# Service Bulletin

Bulletin No.: 16-NA-085

**Subject: New Design Cylinder Heads**

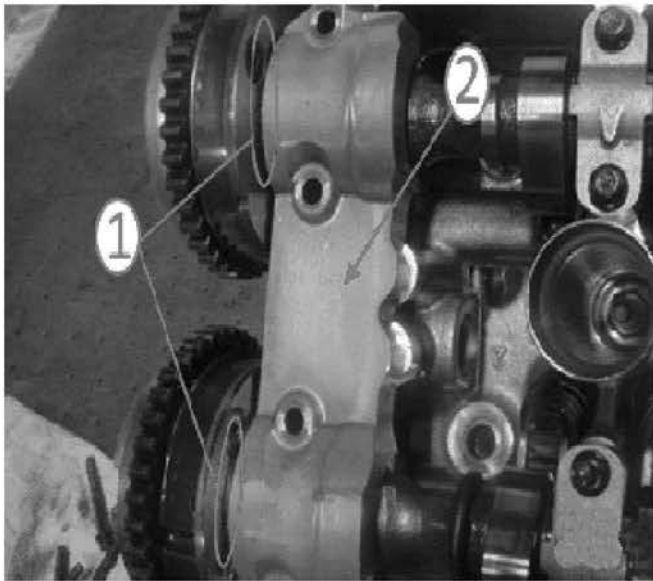
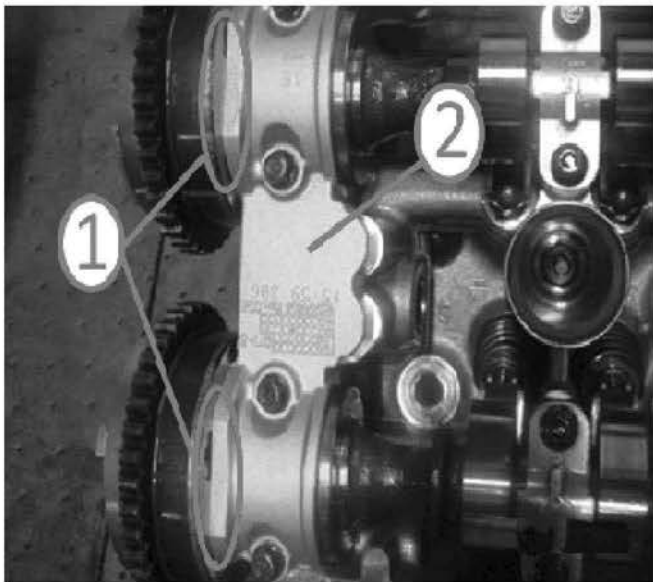
Previously Designed Cylinder Heads used a thrust washer (1) between the actuators and cylinder heads.

The new cylinder heads have a saddle cap (2), which incorporated a thrust surface on the saddle cap, has been designed to reduce the tolerance between the camshaft actuator and cylinder head, eliminating the need for a thrust washer.

**Caution:** If you are using a 2011 new style "saddle cap" cylinder head, thrust washers are not to be used. The use of thrust washers on the new designed cylinder heads can cause damage to the cam shaft actuator, saddle cap and cylinder head.
